TECHNICAL RESPONSE LETTER

Re: Response Letter to WDNR Additional Site Investigation Report Review Letter
1515 N. 10th Street, Milwaukee, WI
BRRTS# 03-41-579223

FIGURE 4-1

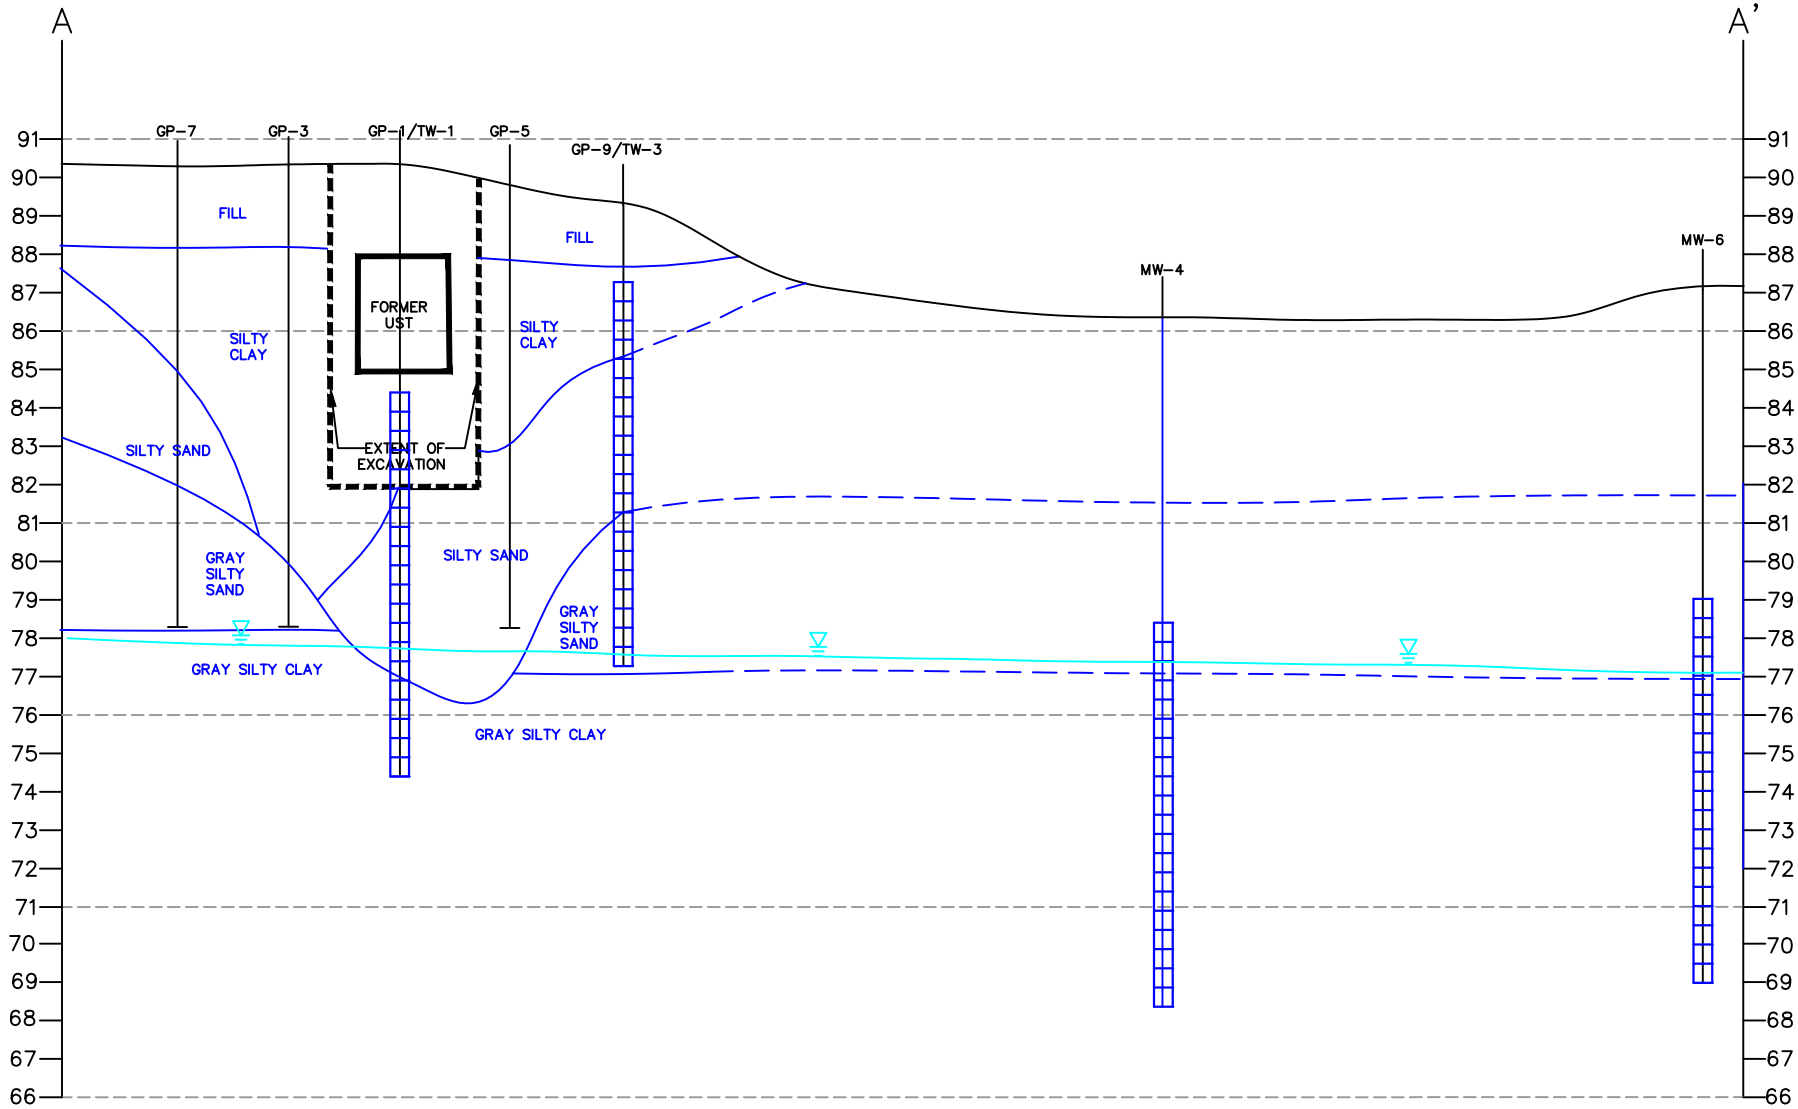
WDNR Item c. Well screen locations for the monitoring wells (including temporary monitoring wells).

WDNR Item d. Location of the water table.

WDNR Items e. The DNR recommends extending the cross-section laterally as needed to ensure the estimated extent of groundwater contamination is within the cross-section (i.e. to the recent monitoring well locations).

Response: See attached Figure 4-1.

Response: See attached Figures 4-1, 4-2 and 4-3.

Response: See attached Figures 4-1, 4-2 and 4-3.

FIGURE 4-2

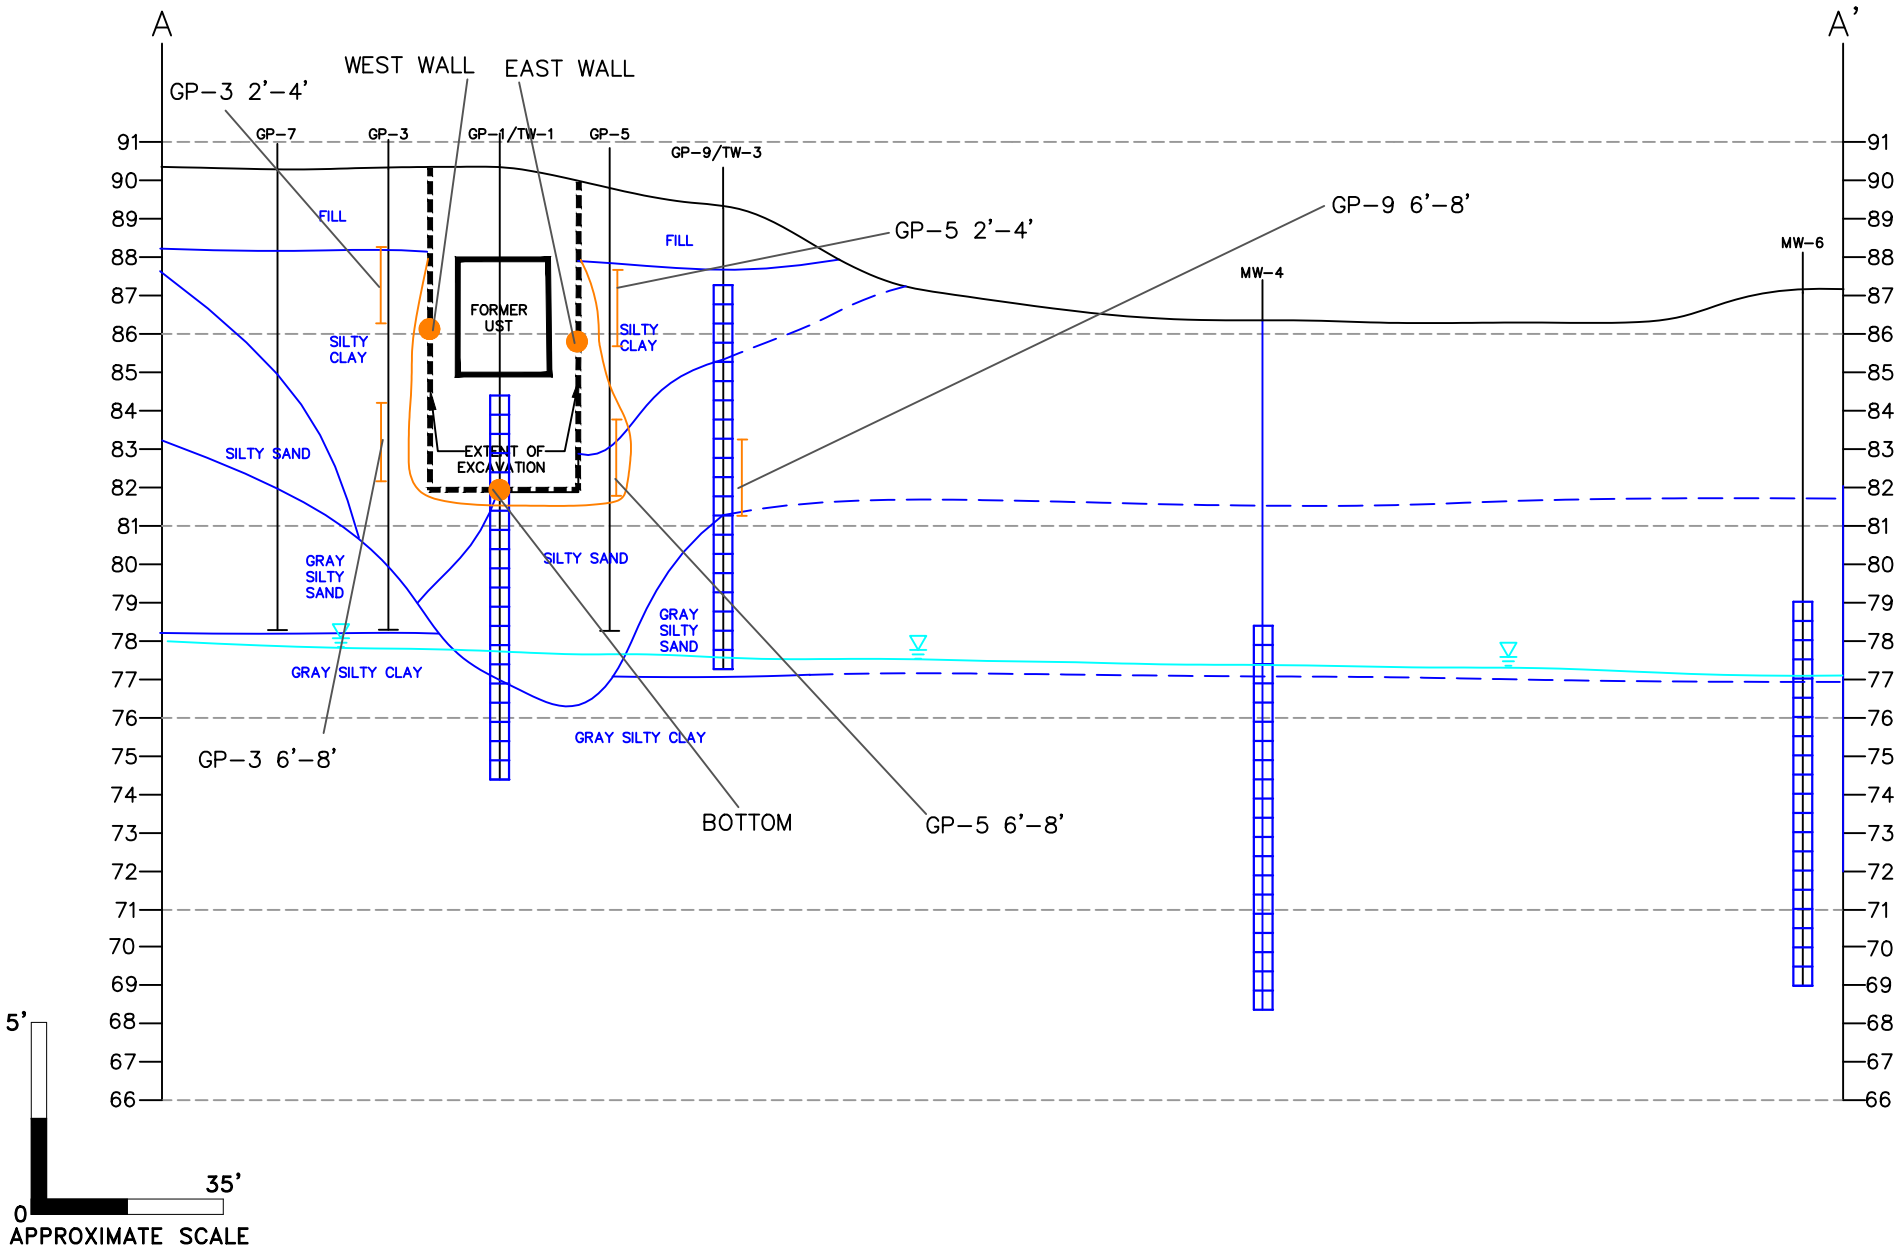
> **WDNR Item a.** Isoconcentration contour lines indicating the extent of soil contamination above NR 720 RCLs and groundwater contamination above preventive action limits.

WDNR Item b. Location of soil and groundwater samples and relevant results to support the isoconcentration lines. Include the excavation soil samples.

Response: See attached Figures 4-2 and 4-3.

Response: See attached Figures 4-2 and 4-3.

FIGURE 6

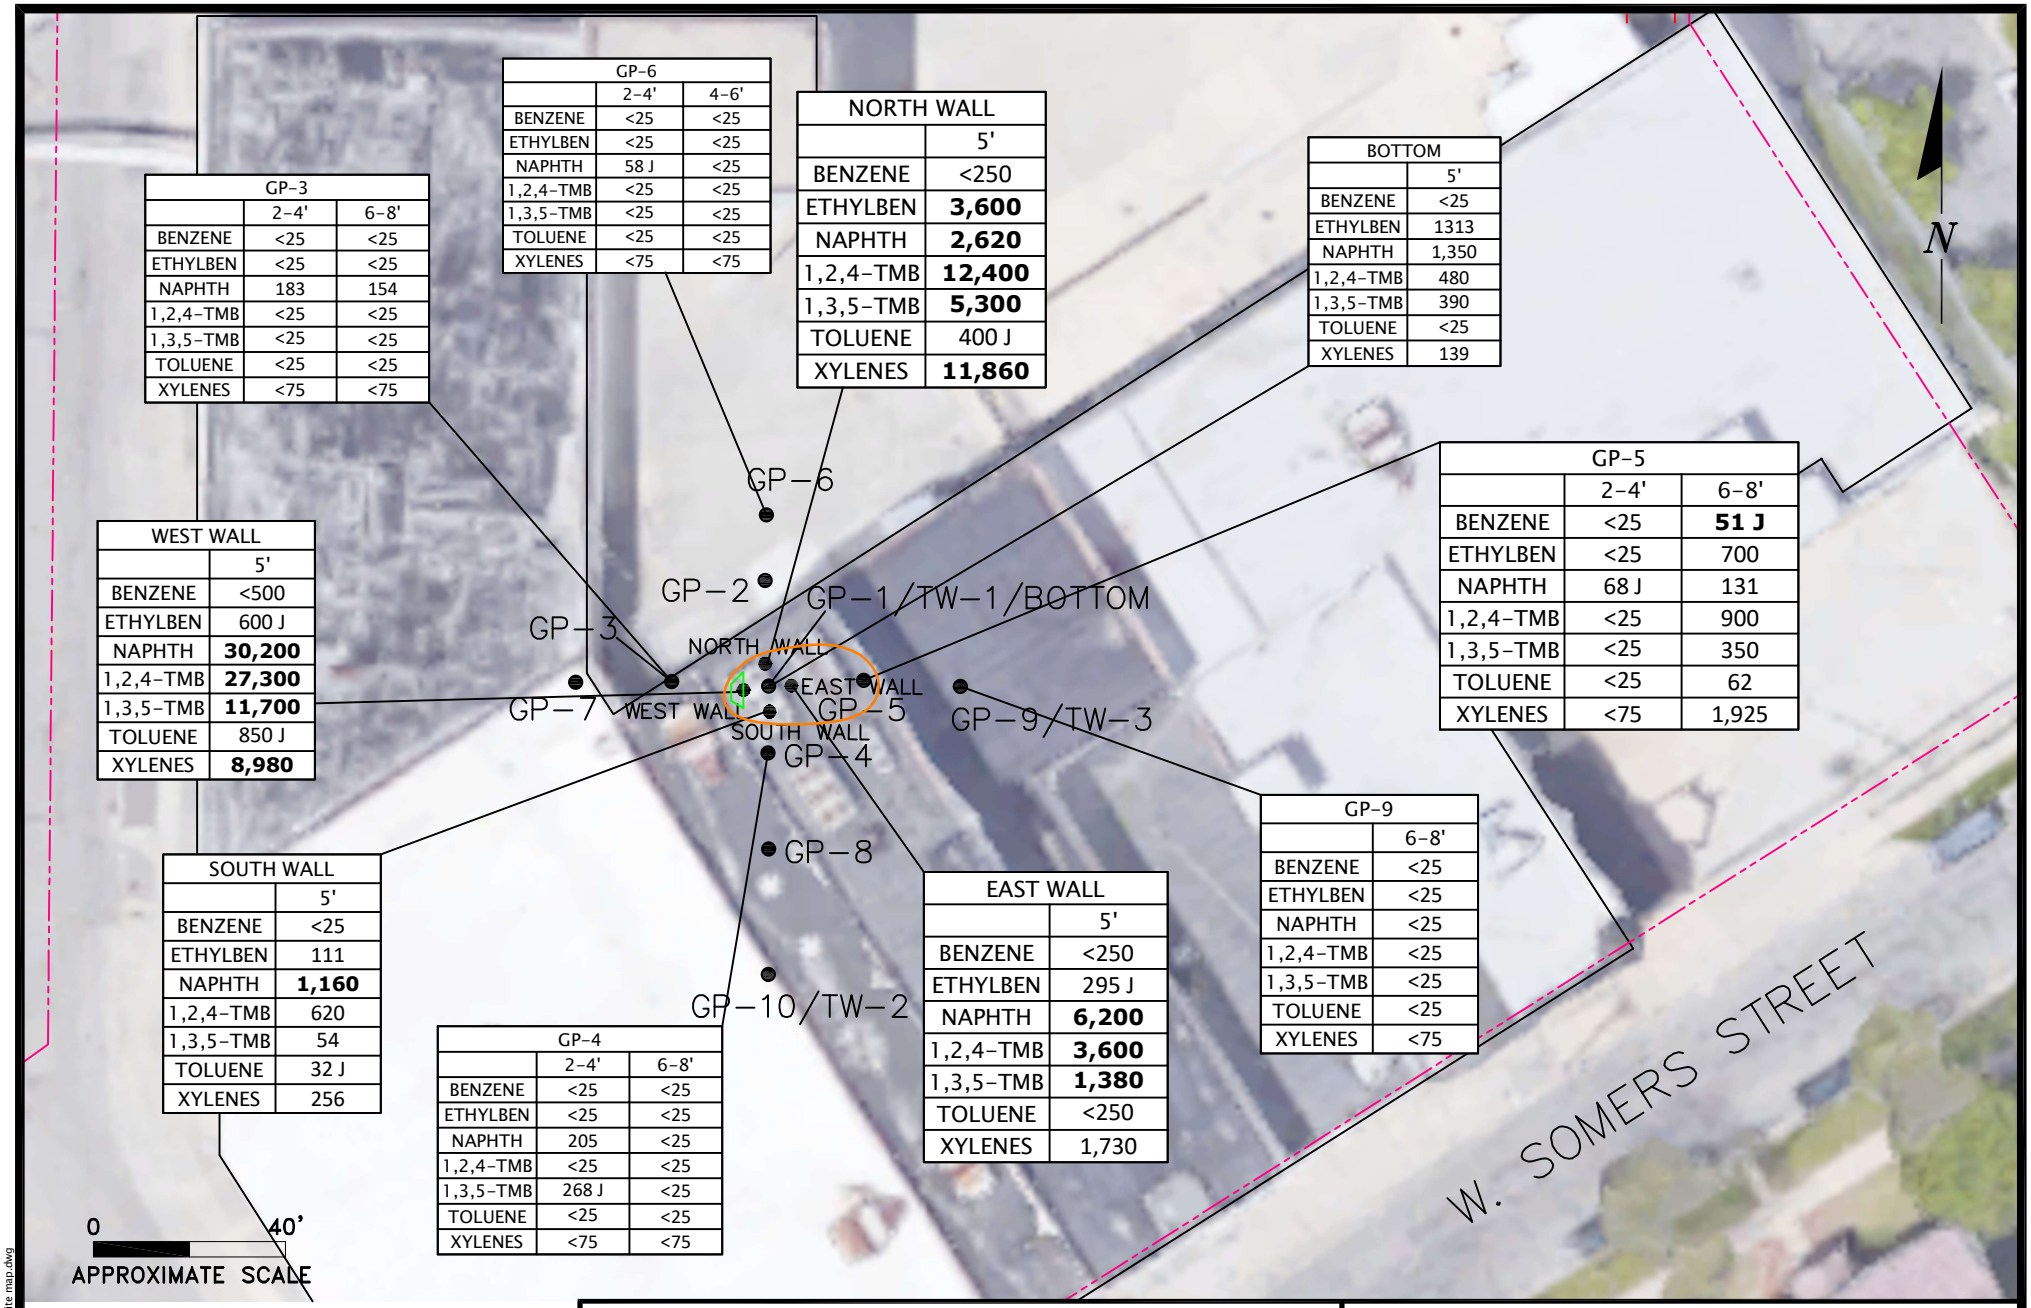
WDNR Comment 7. The figure titled "Aerial Extent of Soil Impacts" should be revised to include isoconcentration lines for relevant contaminants, the excavation soil samples and their depths, and non-detect soil data to support the soil contamination isoconcentration line placement.

Response: See attached revised Figure 6.
